**NFPA Technical Committee on Electric Generating Plants (ECG-AAA)
NFPA 850 First Draft Meeting (F2025)
NFPA 853 Second Draft Meeting (F2024)**

NFPA Technical Committee on Electric Generating Plants (ECG-AAA) NFPA 850 and 853 First Draft Meeting (F2024)

Revise Chapter 1 based on work by Task Group 1 to update the language to reflect the change from a recommended practice to a Standard.

Figure 6.1.4.3.1 Illustration of Oil-Insulated Transformer Separation ~~Recommendations~~.

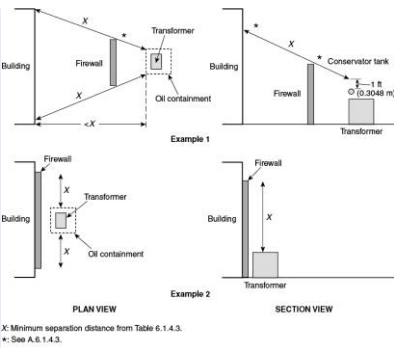
Commented [KS11]: SL: This should be the same measurement shown in the figure.

Where a firewall is provided between structures and a transformer, it shall extend vertically and horizontally and extend at least 1 ft (0.31 m) above the top of the transformer casing and oil conservator tank and at least the width of the transformer oil containment as indicated in Figure 6.1.4.3.1.

Figure 4.4.5 Fire Protection Design Basis Process Flow Chart.

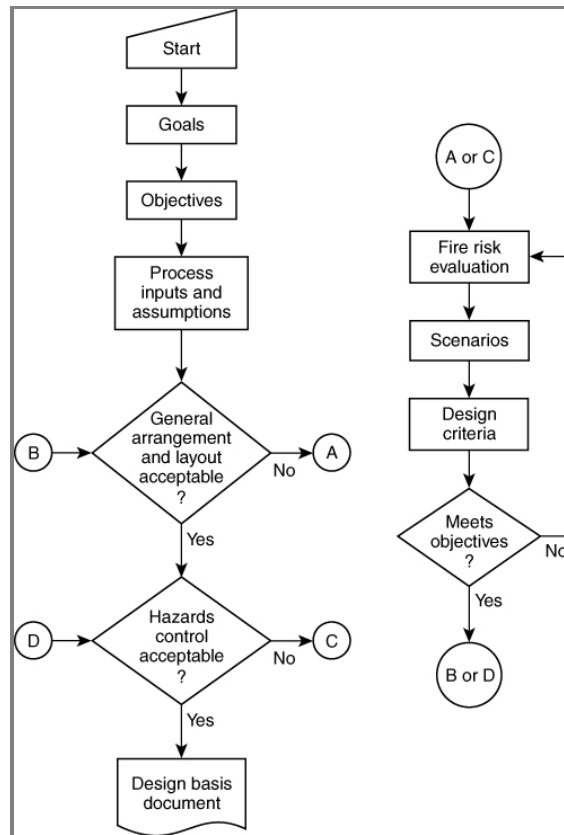
Commented [ECG37R36]: TG1 - These reflect the steps in the below flow chart (Figure 4.4.5). Redundancy is acceptable.

Commented [ECG39R38]: TG1 - These reflect the steps in the below flow chart (Figure 4.4.5). Redundancy is acceptable.

~~As the project evolves, the The~~ FPDBD shall be reviewed and updated as necessary ~~throughout the project~~ to incorporate changes and revisions. (See Figure 4.4.7.)

Figure 6.1.4.4 Outdoor Oil-Insulated Transformer Separation Criteria.

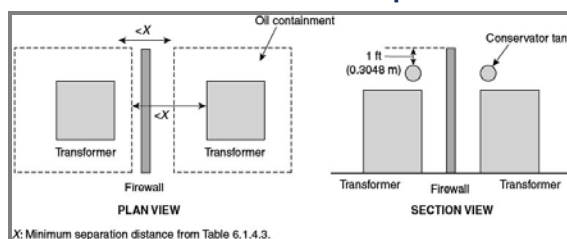
Commented [KS15]: SL: If this contains the mandatory requirements from 6.1.4.6, it should appear in the mandatory text. Also the measurements in-text should match those in the figure.

Commented [JAP(616)]: Renumber figure

Where a firewall is provided between transformers, it shall extend at least 1 ft (0.31 m) above the top of the transformer casing and oil conservator tank and at least 2 ft (0.61 m) beyond the width of the transformer and cooling radiators, or to the edge of the containment area, whichever is greater, [as indicated in Figure 6.1.4.6](#) unless the FPDBD analysis in 6.1.4.2 indicates otherwise.
